North Dakota Department of Transportation

ADDENDUM 1 – JOB 7

TO: All prospective bidders on project SU-3-982(031)035, NHU-3-019(044)155 & NHU-3-020(074)103, Job No. 7 scheduled for the October 14, 2016 bid opening.

ND Highway 20
 Retaining Wall, Pedestrian Railing
 & Guard Post-Permanent Detail

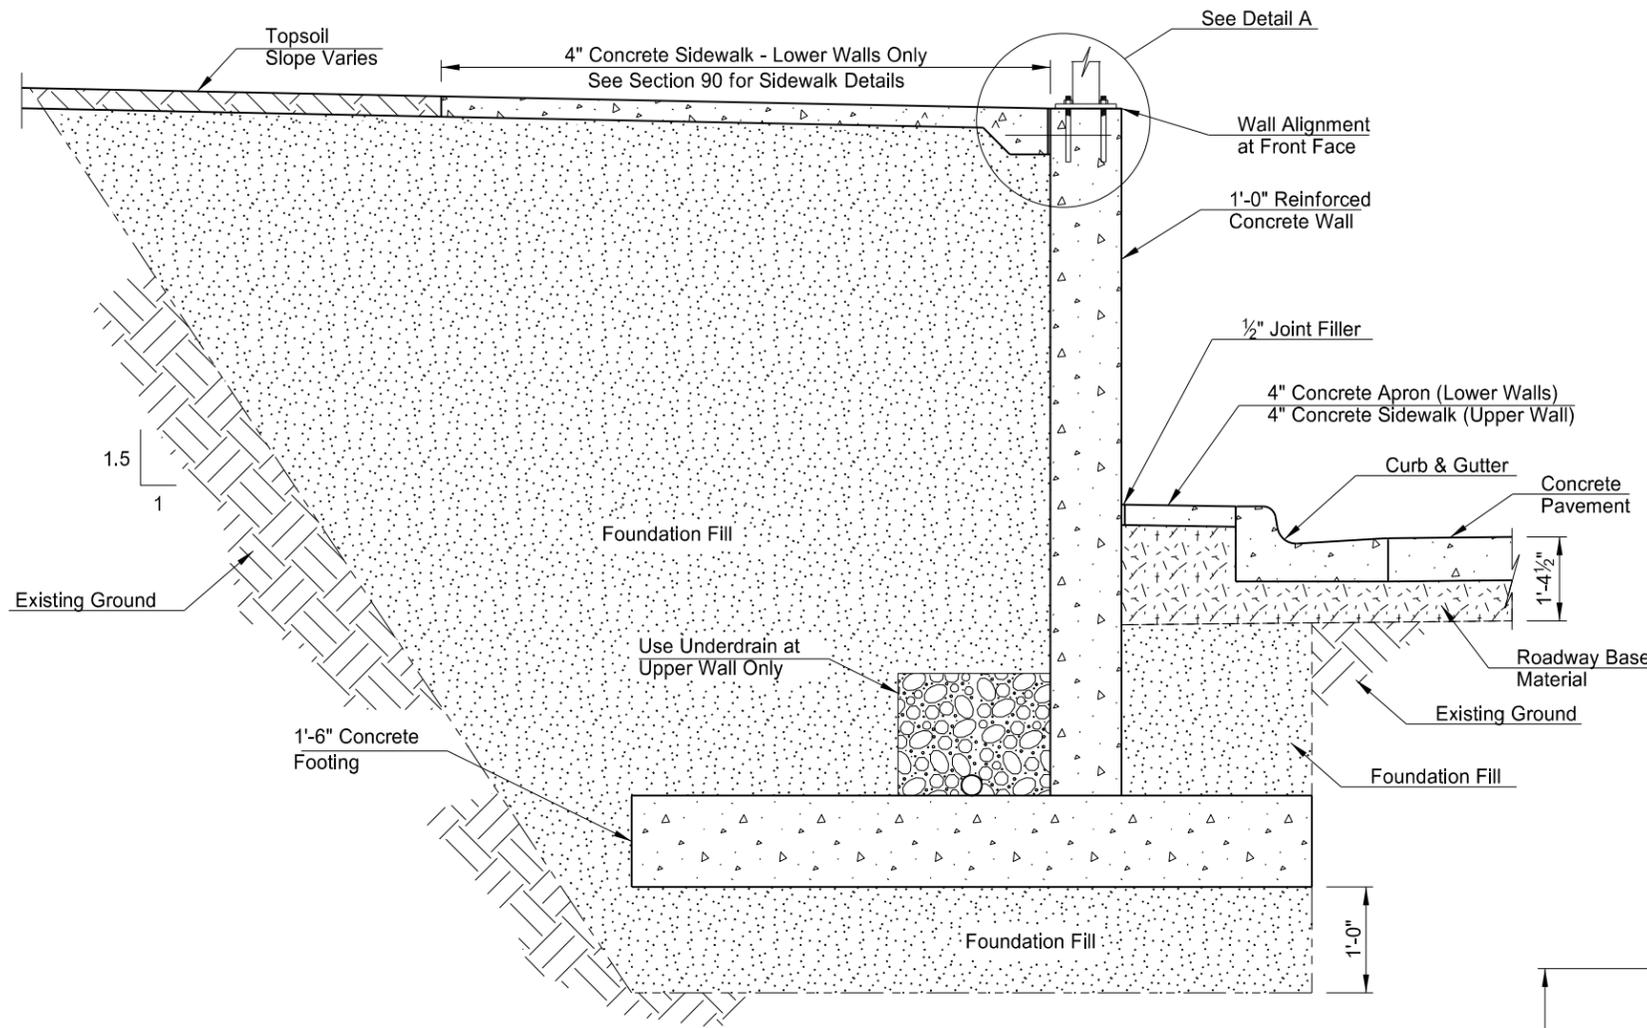
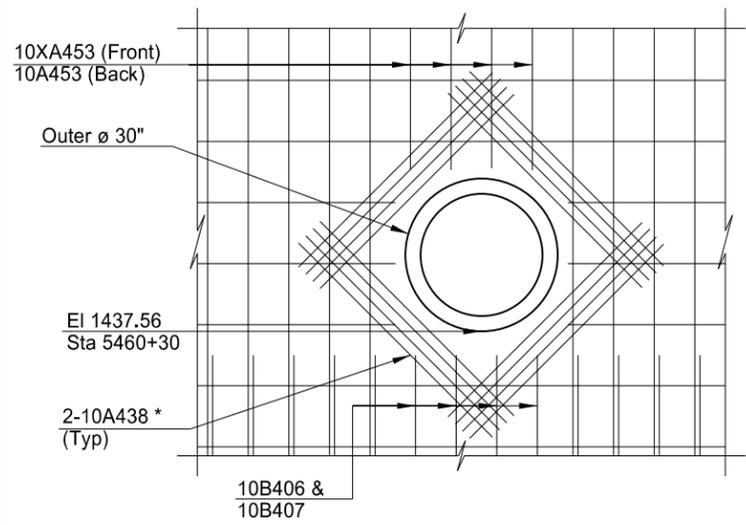
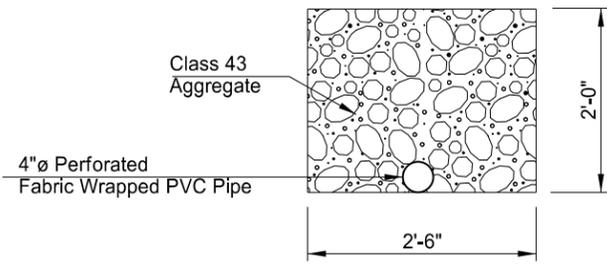
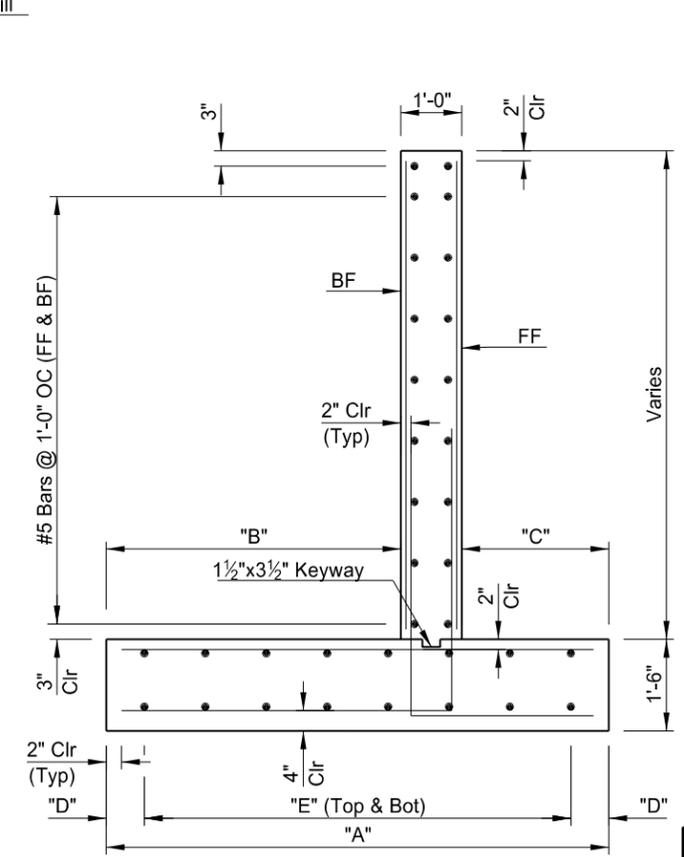
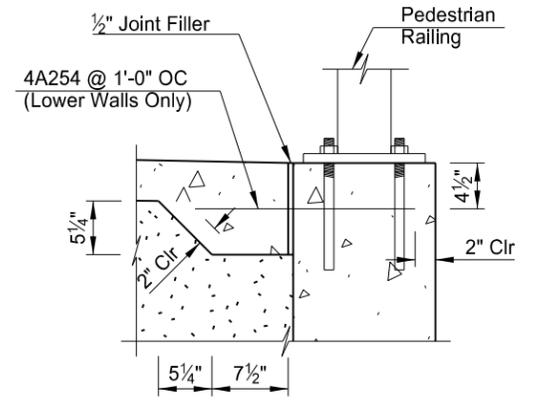
SHEET 38:

- Sheet has been deleted.
- Reference to concrete footing have been deleted.
- Sheet 39 has been updated to Sheet 38.
- **Added 4" spacing for the ¾" pickets**

ND Highway 19 & ND Highway 20
Pedestrian Railing Details

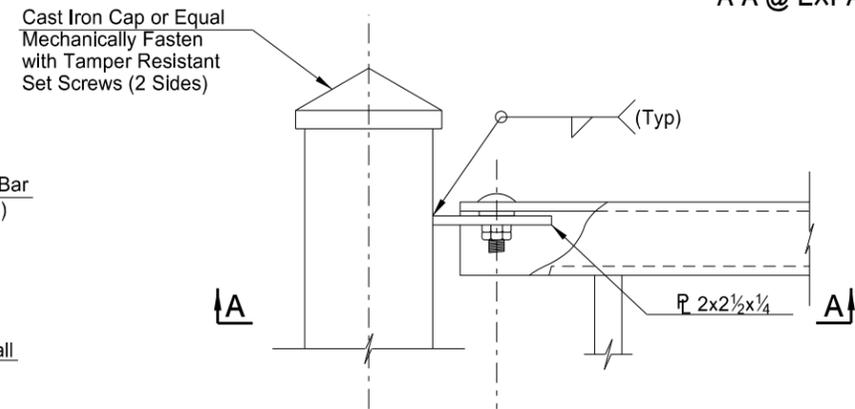
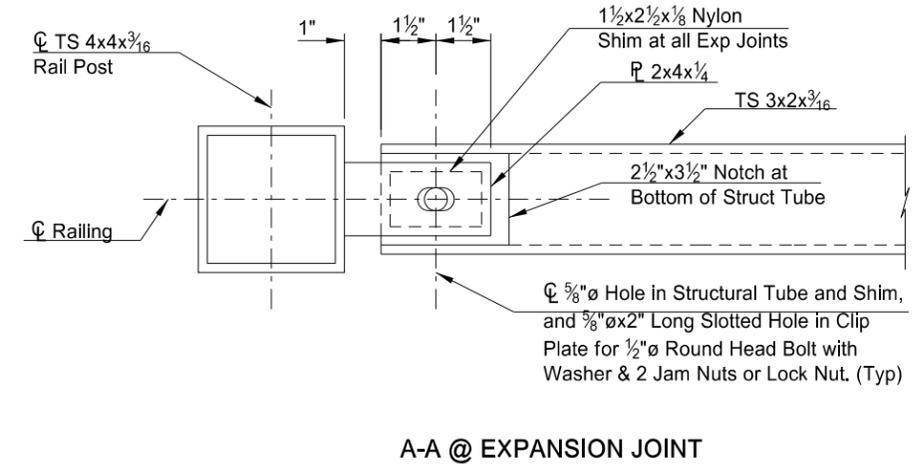
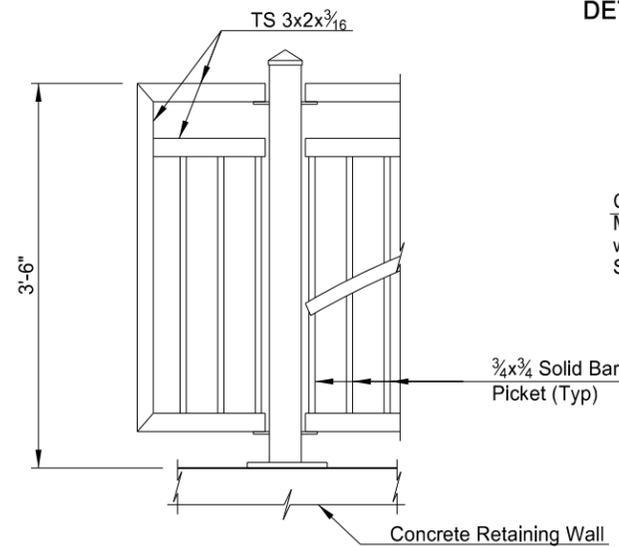
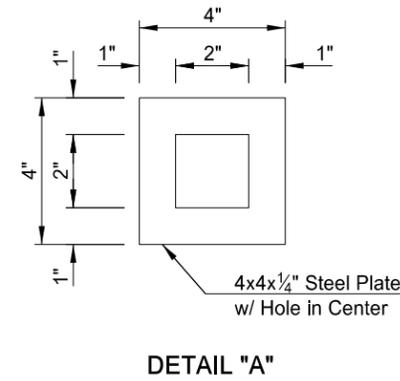
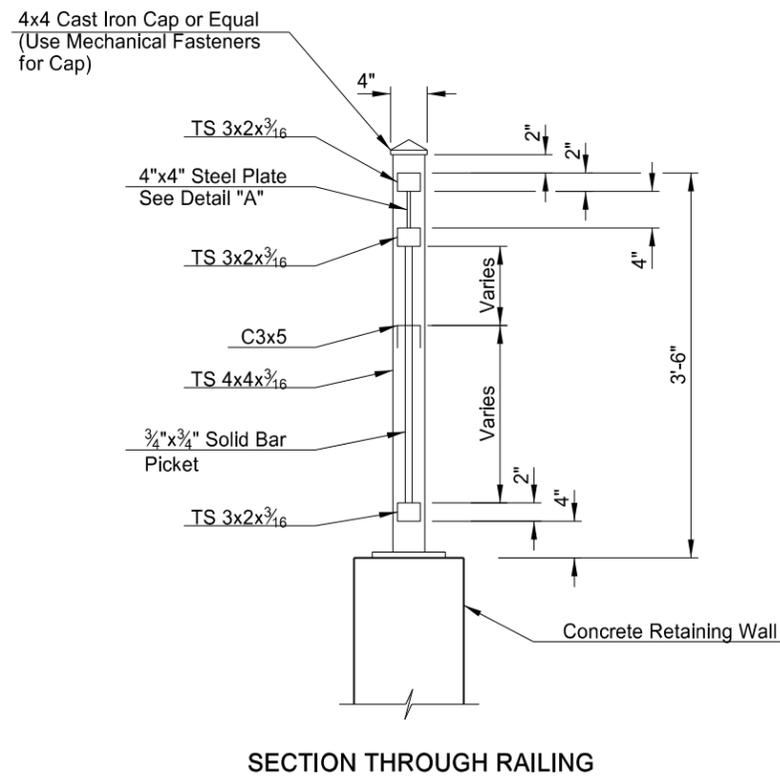
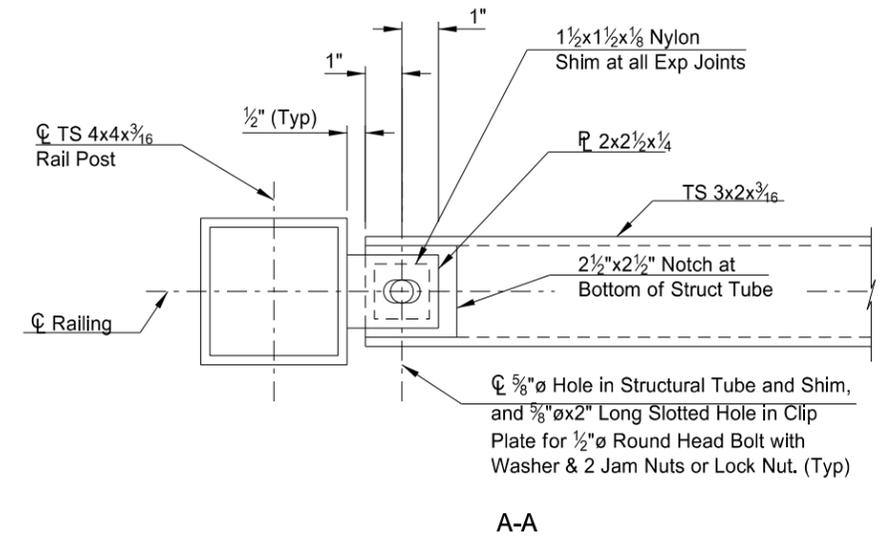
SHEET 39:

- Guard Post-Permanent detail has been added.

GUARD POST-PERMANENT
NOT TO SCALE

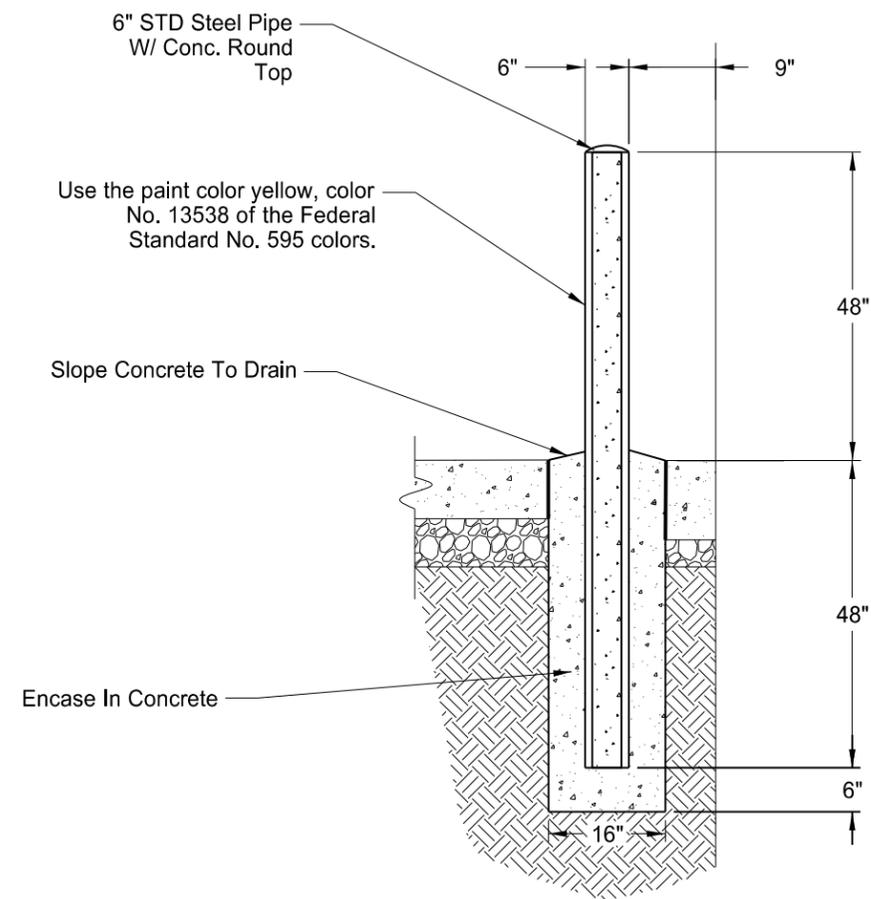
SHEET 17:

- Removed 60 LF of Pedestrian Railing. Added Guard Post-Permanent, 10 EA.

Paving Summary

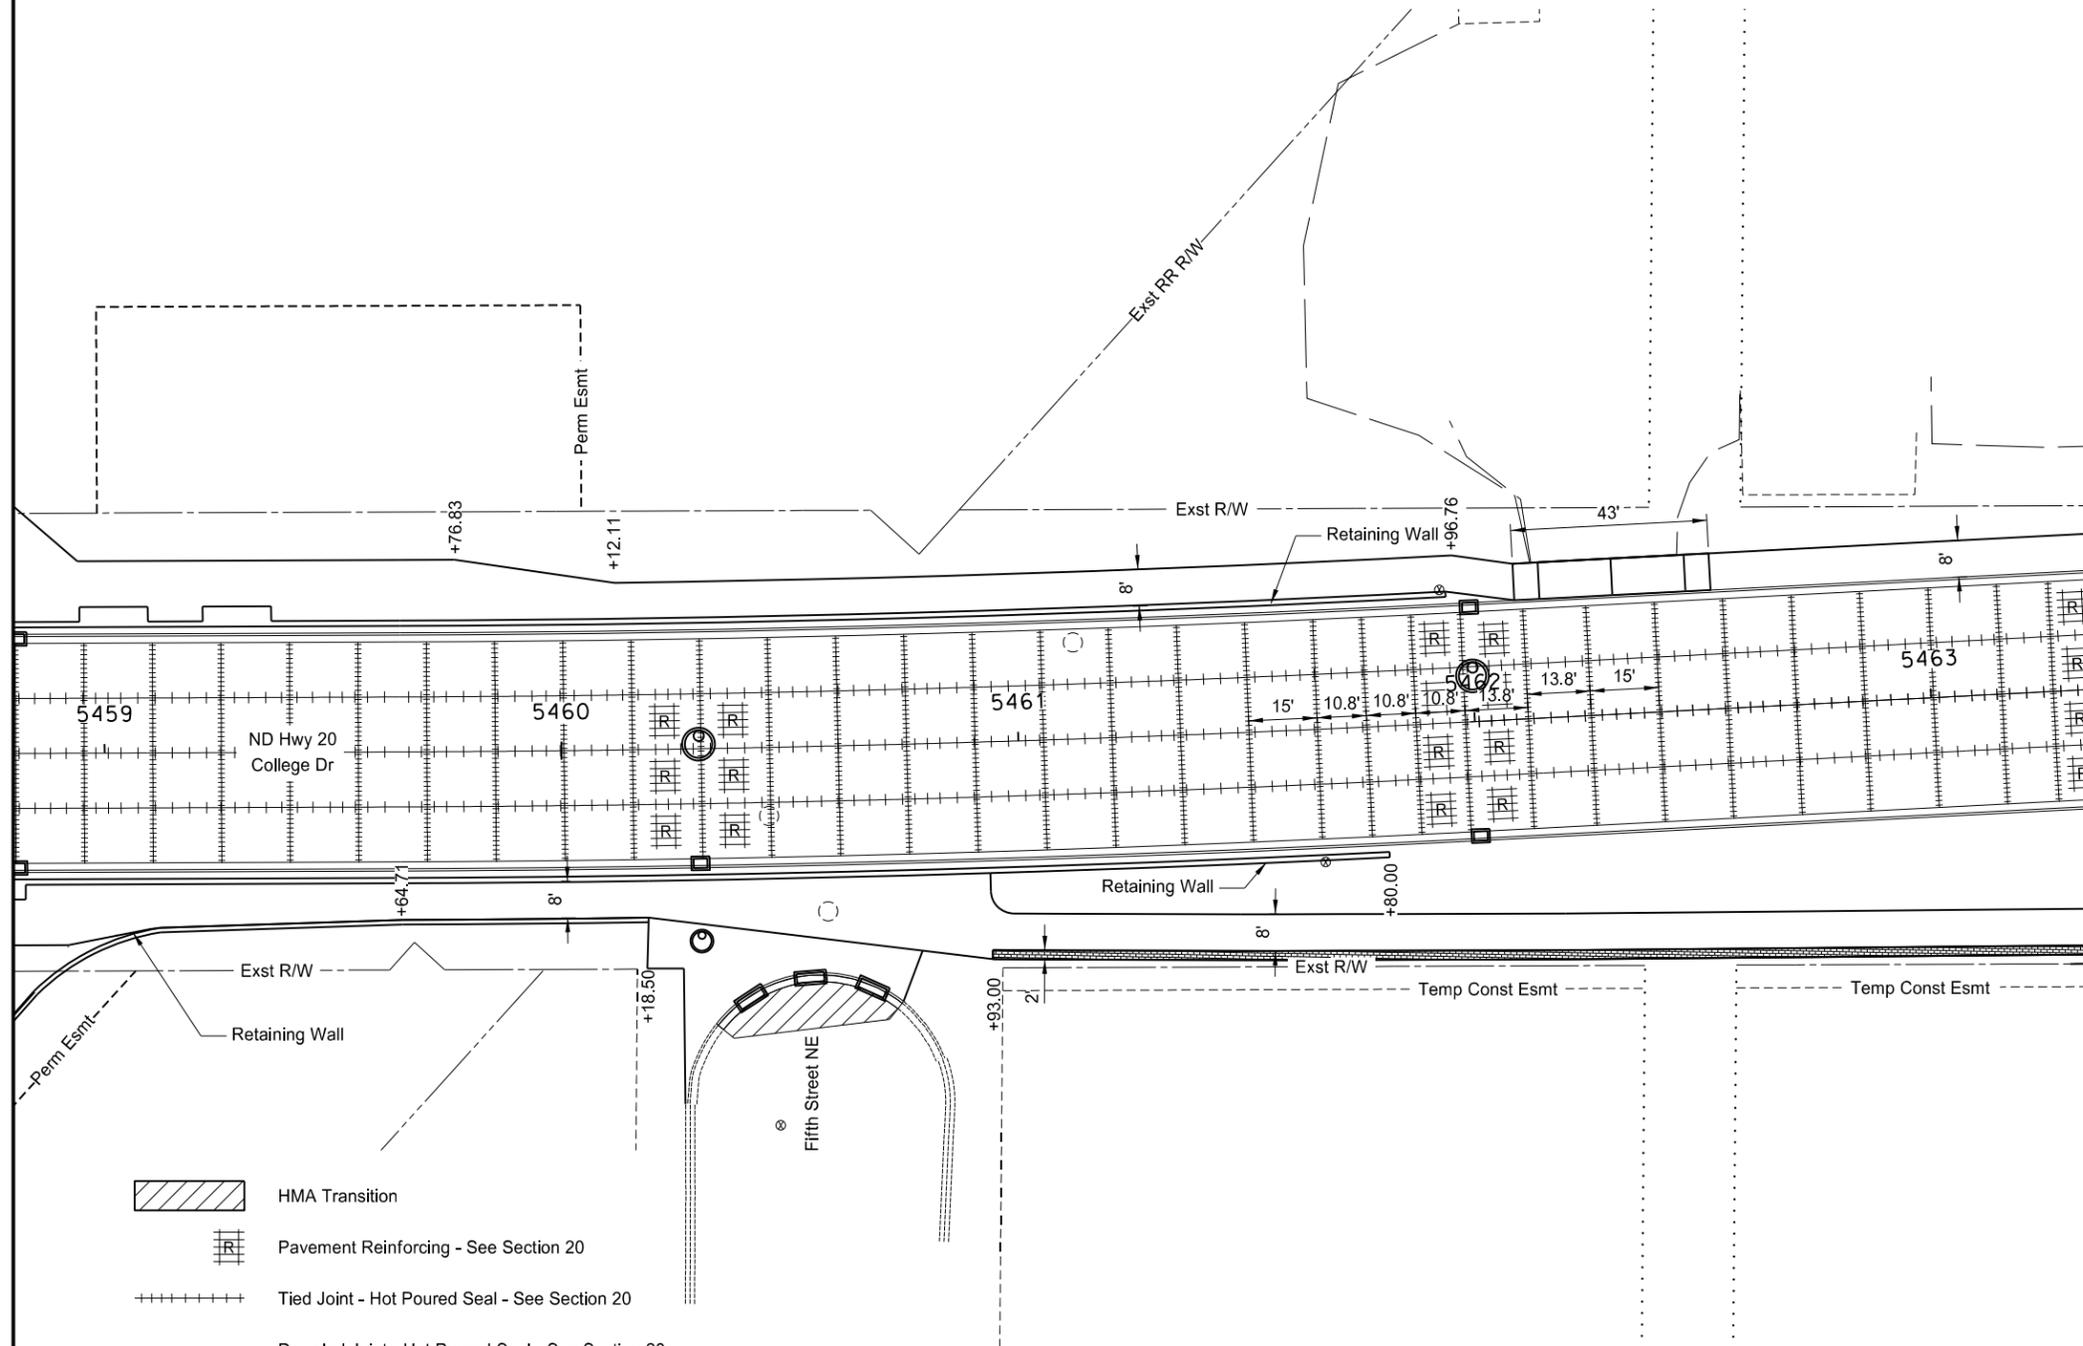
SHEET 6:

- Added Pigmented Imprinted Concrete and updated dimensions.
